INDIANA DEPARTMENT OF TRANSPORTATION

STANDARDS COMMITTEE MEETING MINUTES

RE: Minutes for the September 20, 2007 Standards Committee Meeting

STANDARD DRAWING NO. E 715-BKFL-03

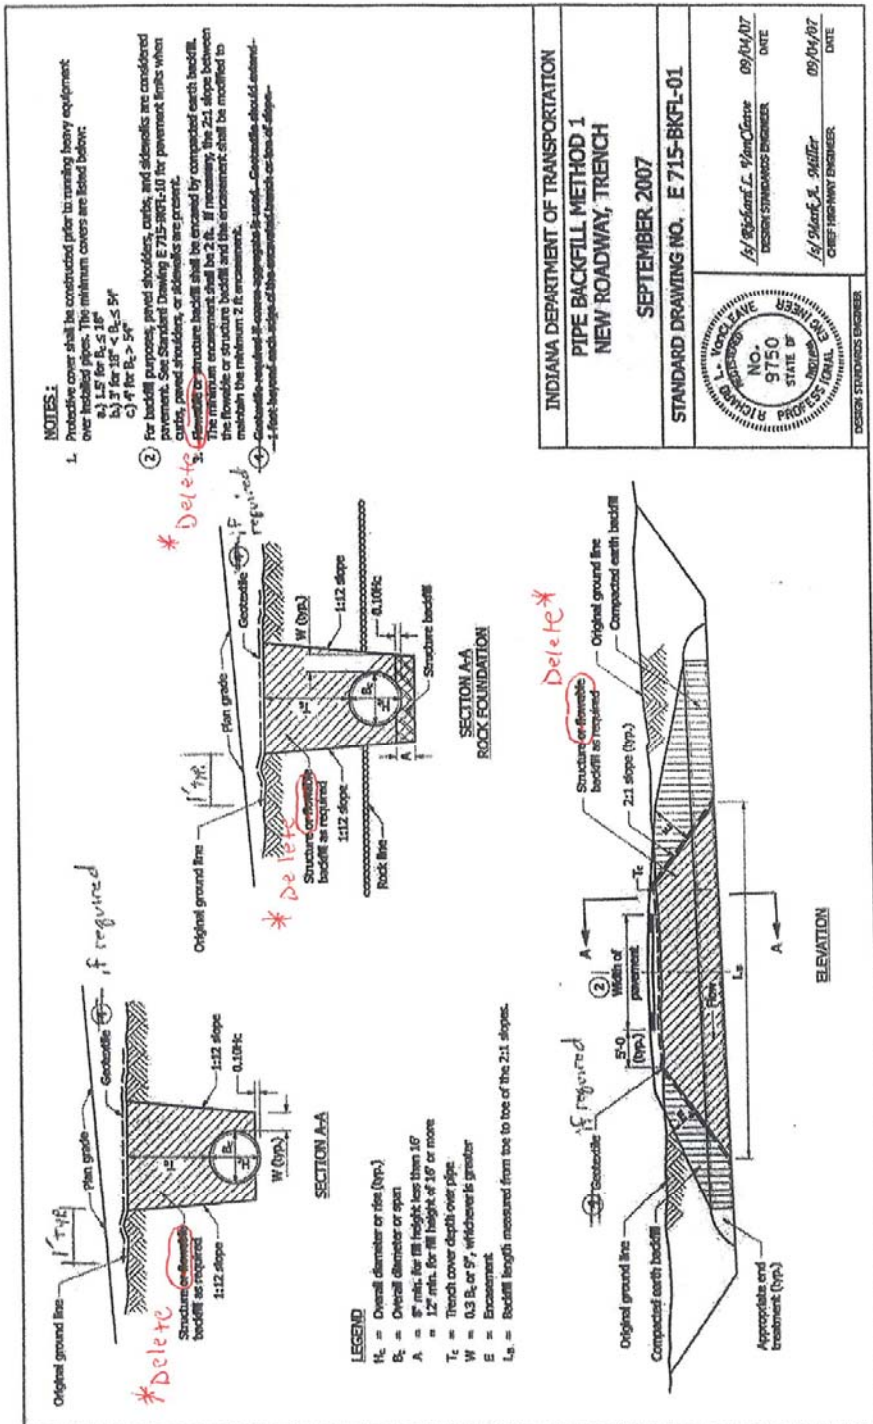
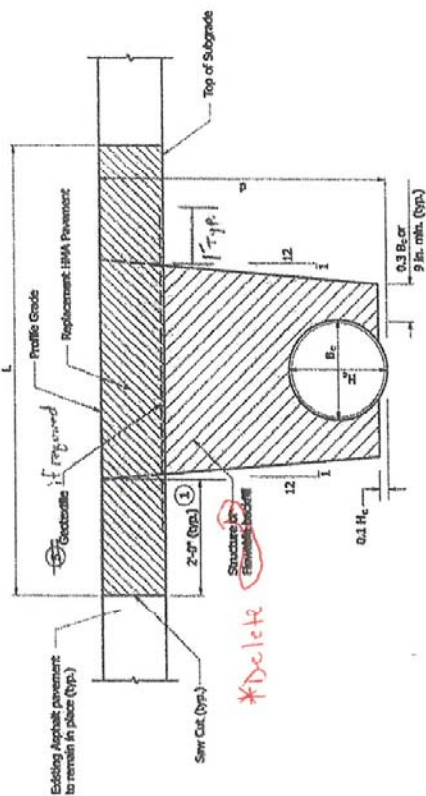
* Delete references to flowable fill (revised at Standards Meeting)

INDIANA DEPARTMENT OF TRANSPORTATION	
PIPE BACKFILL, METHOD 1 EXISTING ROADWAY, TRENCH	
SEPTEMBER 2007	
STANDARD DRAWING NO. E 715-BKFL-04	
	Richard L. VanCleave DESIGN STRONGS ENGINEER DATE 09/04/07
	Mark A. Miller CHIEF HIGHWAY ENGINEER DATE 09/04/07

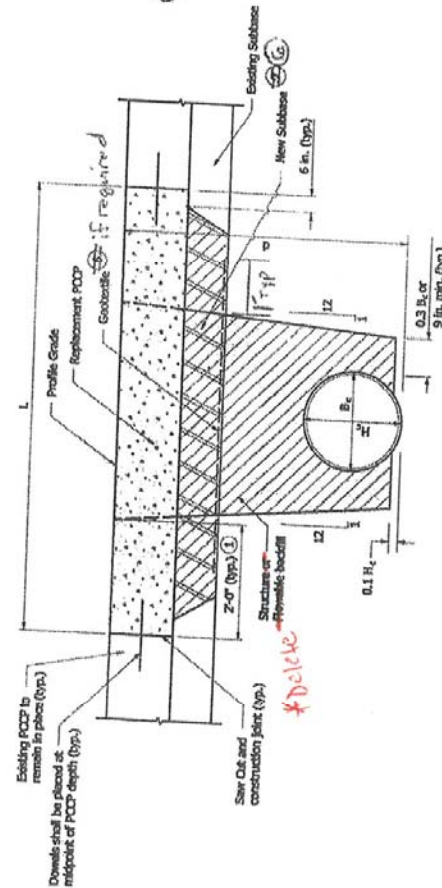
* Delete Reference to Flowable Fill as Revised at Standards Meeting

STANDARD DRAWING NO. E 715-BKFL-05

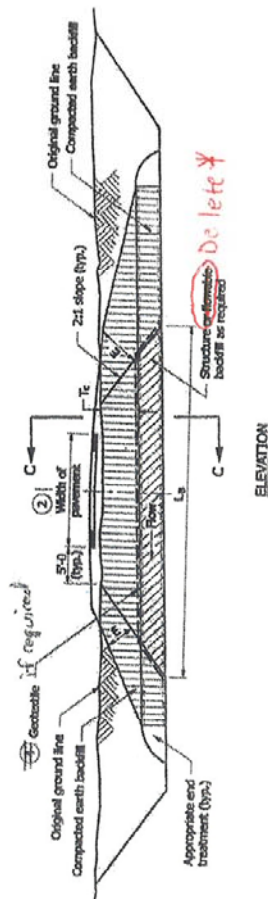
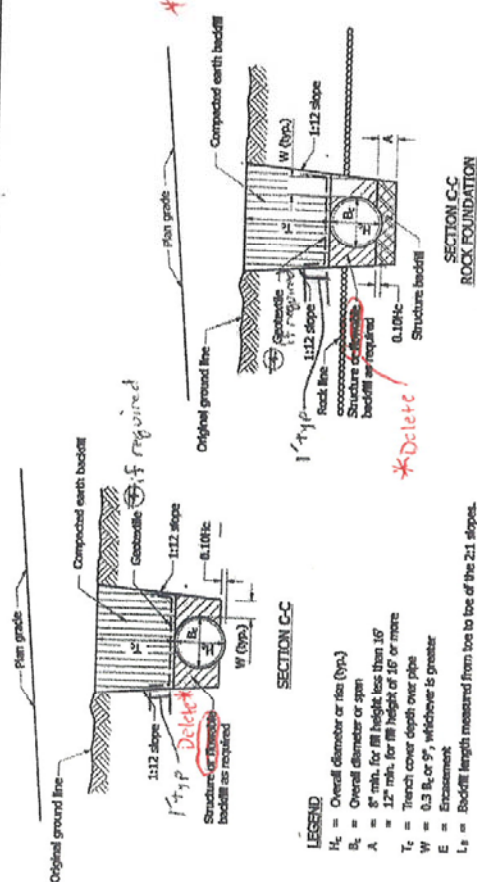
Delete References to Flowable Fill as Revised at Standards Meeting

STANDARD DRAWING NO. E 715-BKFL-06

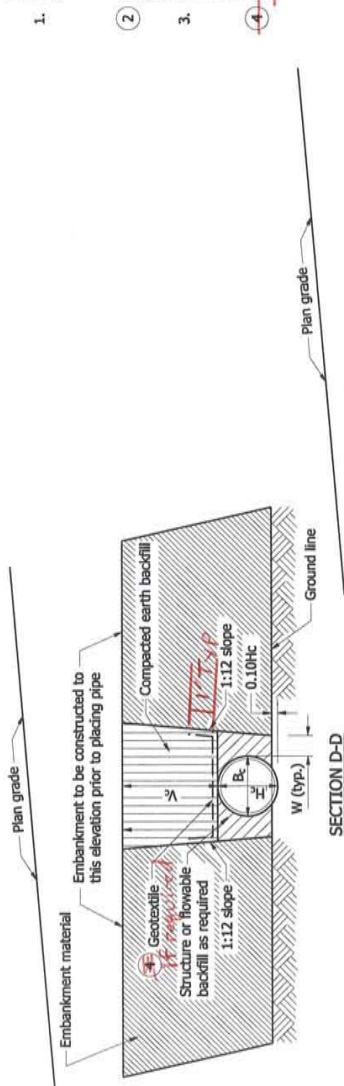
- * Delete References to Flowable Fill as Revised at Standards Meeting

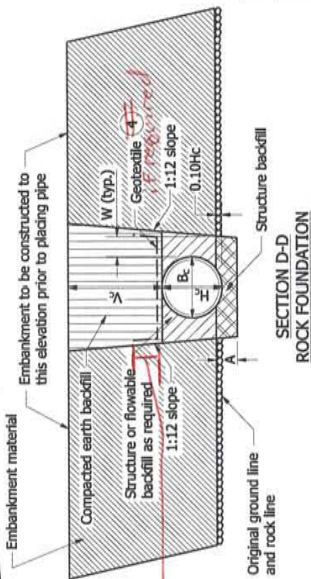
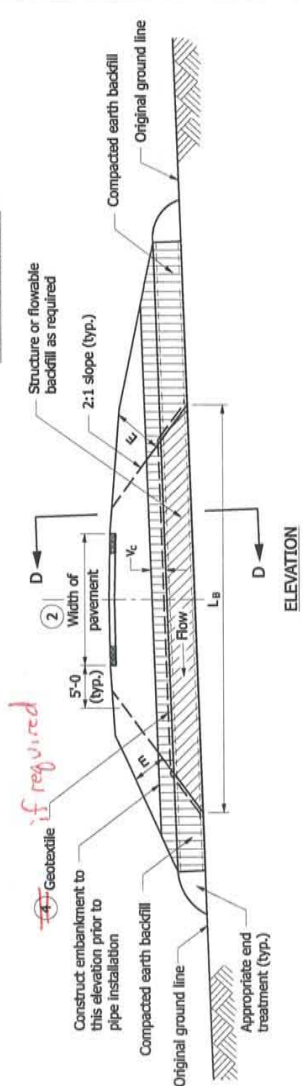
* Delete References to Flowable Fill as Revised at Standards Meeting

STANDARD DRAWING NO. E 715-BKFL-08

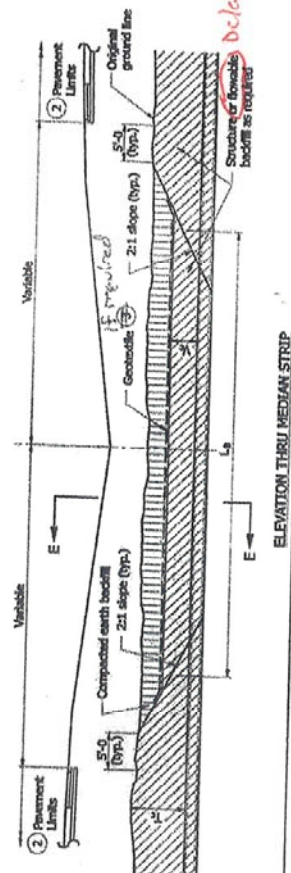
* Delete References to Flowable Fill as Revised at Standards Meeting,
